MINI THERMOSTAT REDESIGN TO OVERCOME OVERHEATING ISSUES

Issue Date: 23/09/19 Issue Number: COTB0027F

APPLICATION: Mini R55, R56, R57, R58, R59, R60, R61

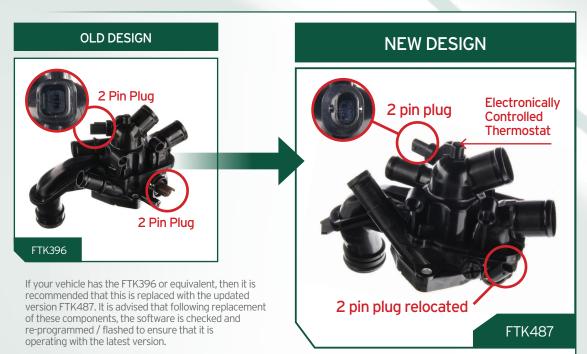
Due to an increase in overheating issues & symptoms such as an erratic temperature gauge, erratic running, radiator fan run-on, or poor heater function in the above vehicles, the O.E.M. have modified the design of the Thermostat housing. Following the O.E. specification, we have replaced the old design FTK396 with the new latest design FTK487. The latest design benefits from an electronically controlled thermostat, a reinforced structure, and a new configuration of sensors.

We have highlighted the key differences below so that you are clear that the latest part; although visually different to what may be on the vehicle, is in fact the correct product.

The modified version has had the lower 2 Pin connector relocated, therefore, a new cable may also be required to carry out the modification.

New Cable: FTS3092- Thermostat Wiring Harness
